Town and Country Planning Act 1990
Section 78 Planning Appeal

London Borough of Hillingdon Appeal Statement

Proposal:
Alterations and extension to existing extension to create new end of terrace dwelling with associated amenity, parking and bin storage

Appeal Site:
123A Central Avenue, Hayes, UB3 2BS

Figure 1- Drawing 1037-11 Rev 08 compared to 3D visual images

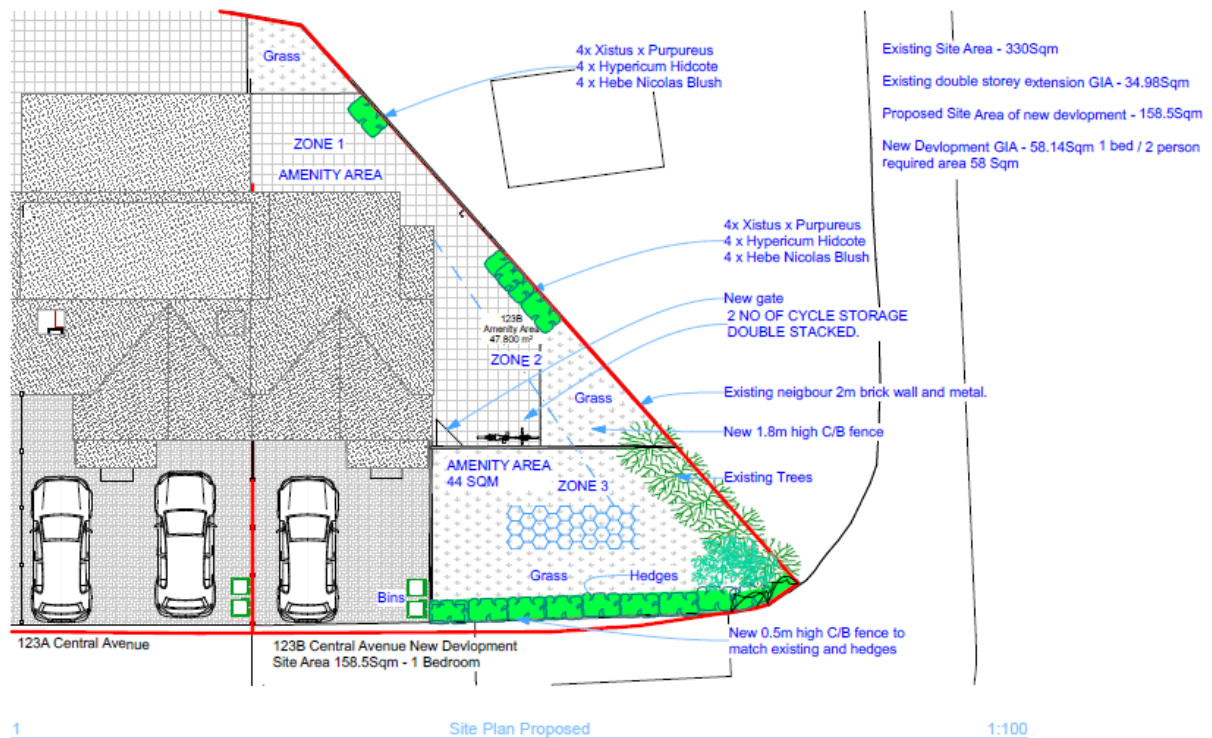
- 2.10 In addition to this, the proposed landscaping scheme illustrated on drawing reference 1037-11Rev 08 does not correlate with the 3D-visual which has been submitted (include both below).

- 2.11 While the applicant states that 'Amenity Zone 3' is secondary space and the quantum of amenity space can be provided within Zones 1 and 2, it is clear that Zone 3 is the most attractive for future occupants given its overall space and size.

- 2.12 However, given its location 4.5 metres in depth forward of the front elevation and abutting the public highway this area is clearly not private and would be significantly overlooked by pedestrians and vehicle users. Although there is a fence and hedge proposed, it is 0.5 m in height which would not provide the required screening to protect occupants from the unacceptable levels of overlooking. As such this area would not meet the requirements of Policy DMHB 18 of the Local Plan, Part 2 (2020). As detailed further within sections 2.24-2.27 of this statement, the other zones are awkwardly shaped due to their angular nature and are not considered well located nor adequately useable.

Figure 2- Screenshot of site plan showing angled site boundary, distances to side boundary and uncharacteristically sized rear garden.

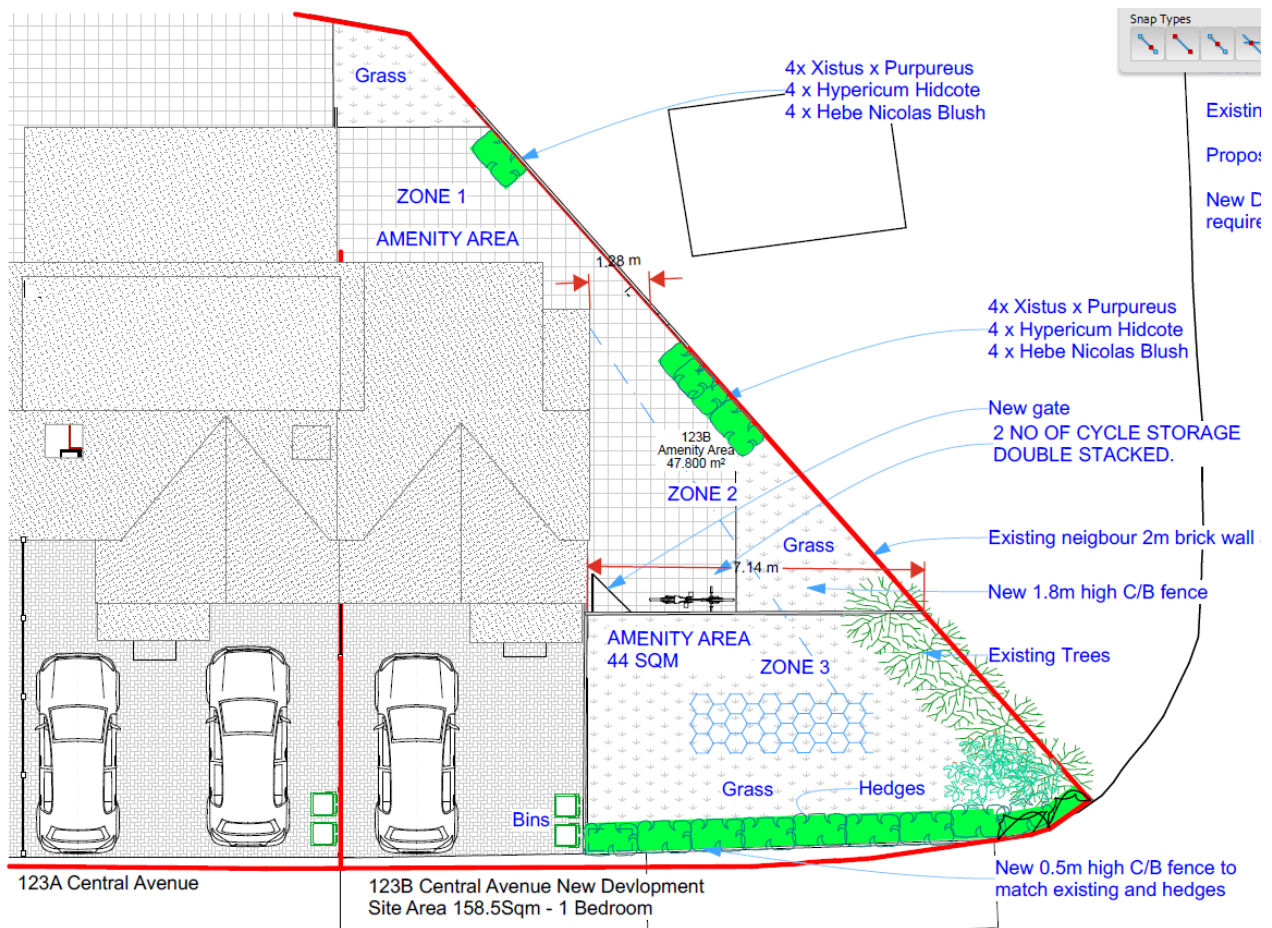
- 2.19 In response to paragraphs 5.12 – 5.16 of the appellants SOC, the delegated officer's report provides a detailed and robust assessment of the revised proposal, concluding that the development remains unacceptable. While the appellant has included comparative visuals showing the evolution of the front elevation - from the existing side extension to the previously dismissed scheme, and now the current proposal - the changes do not sufficiently address the fundamental concerns. Although the width of the proposed dwelling has been reduced, the scheme would still appear cramped and incongruous within the street scene. The 3D visuals submitted by the appellant are limited in scope, omitting key contextual elements such as the neighbouring properties to the north and the angled nature of the site boundary. This omission undermines the accuracy of the visual representation. While the front elevation may be set back approximately 7 metres from the side boundary, the narrowest point of the proposed dwelling sits just 1.25 metres from the boundary due to the angled corner plot. This limited separation fails to preserve the openness that is characteristic of corner plots within the Central Avenue Area of Special Local Character (ASLC). It is important to note that the openness of this corner site has already been significantly compromised by the existing property and its side extension at No. 123A. The further extension of this already enlarged end-of-terrace dwelling would exacerbate the visual impact, resulting in additional harm to the character and appearance of the street scene and the ASLC. In addition to this, the rear garden of the new dwelling would still appear very small which is uncharacteristic of the area particularly the spacious corner plots which was agreed by the Inspector.

- 2.25 The revised scheme does not overcome these concerns. Although the footprint of the dwelling has been marginally reduced and a side access door introduced, the rear garden remains narrow and awkwardly shaped. The side garden, while slightly more accessible, is still constrained by the angled boundary and proximity to the dwelling. The front garden, which the appellant now describes as “secondary,” remains exposed to public view due to a low hedged boundary (0.5m) and cannot reasonably be considered private or suitable for meaningful use. This area would be the most
